## Interpreting The Secretary of the Interior's Standards for Rehabilitation

### Subject: Changes to Shotgun Interior Plan

Left: Shotgun plan prior to rehabilitation. Right: Shotgun plan post rehabilitation with acceptable changes.

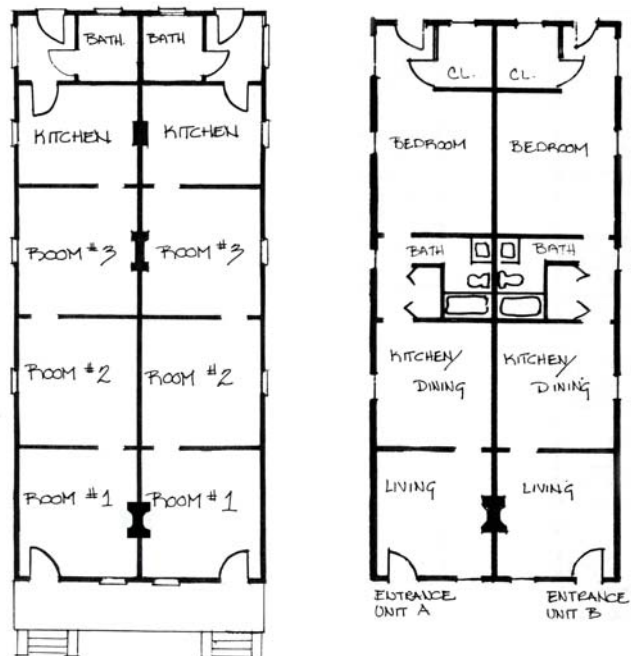
**Application 1 (Compatible treatment):** In the first example, the shotgun plan was generally retained in the rehabilitation with some modifications. Kitchens were inserted into the second room of each half of the duplex; a bathroom and laundry were inserted into the third room. The fourth room on each side of the building was enlarged by moving the partition forward a few feet. Despite these alterations, the historic division of the cottage into two equal units was respected in the rehabilitation. The linear arrangement of small rooms, one behind the other, was also maintained on each side. Thus, on both the exterior and interior, the building has the same appearance as it did historically, as a modest double shotgun cottage. This plan, which largely determines its historic character, remains following the rehabilitation. The project meets the Standards for Rehabilitation.

*Left: Shotgun plan prior to rehabilitation. Center and Right: After rehabilitation, extensive changes made to shotgun plan resulted in denial of project.*

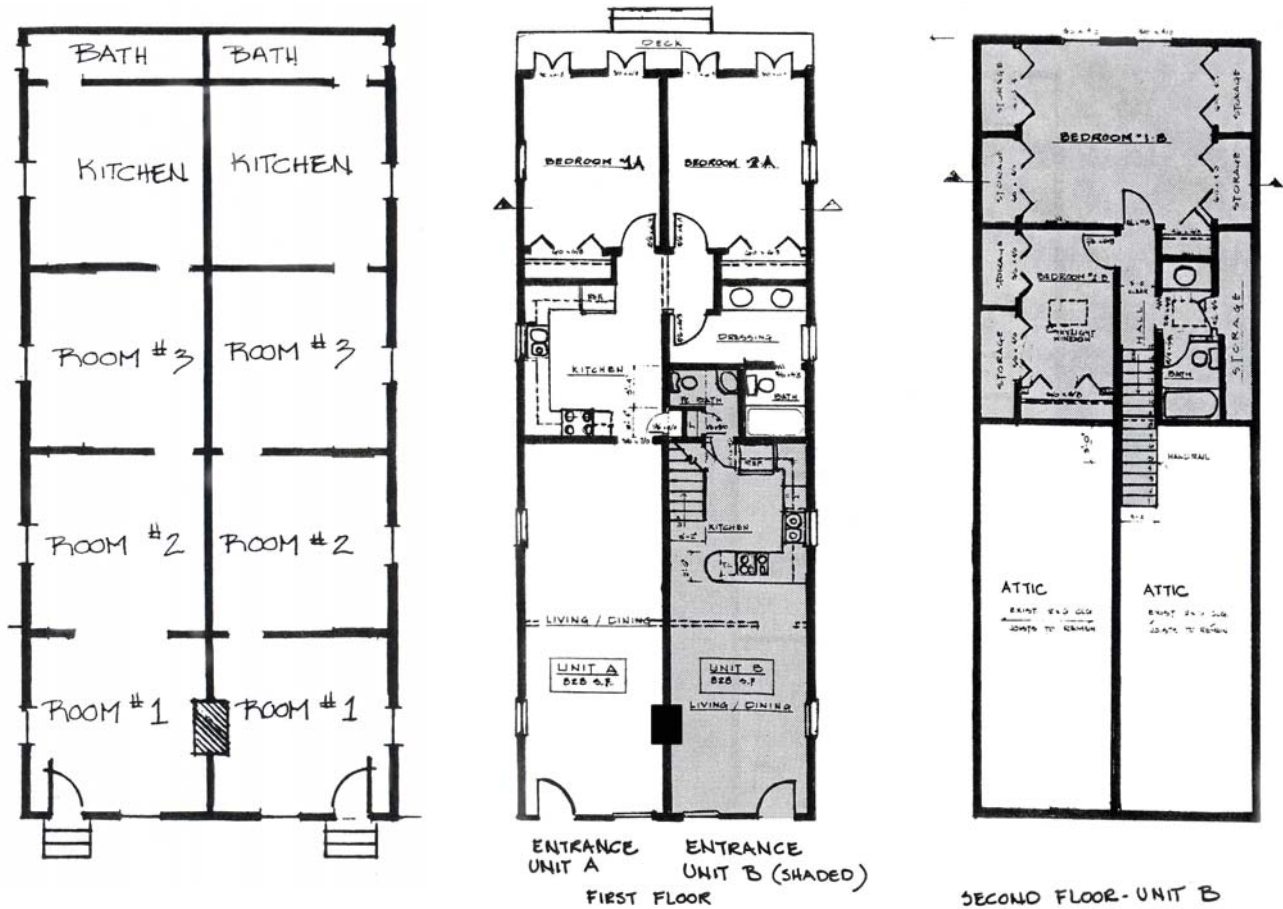
**Application 2 (*Incompatible treatment*):** In the second example, radical changes made during the rehabilitation obliterated the characteristic shotgun plan. The wall between Room #1 and Room #2 in both units was removed to create one large room in each unit. Almost the entire rear half of the unit on the right side was incorporated into Unit A on the left side. This effectively destroyed most of the wall separating the two units that defined the shotgun plan. In addition, greatly truncating the length of Unit B further impacted the plan by eliminating the progression of rooms so typical of shotgun interiors. To make up for the space lost from Unit B on the right side a staircase was added to access two bedrooms that were created in the attic. Converting Unit B from a one-story unit into a two-story unit further altered the historic character of the house. The units no longer convey a sense of the original shotgun plan as a result of these changes. Accordingly, the project fails to meet the Standards for Rehabilitation.
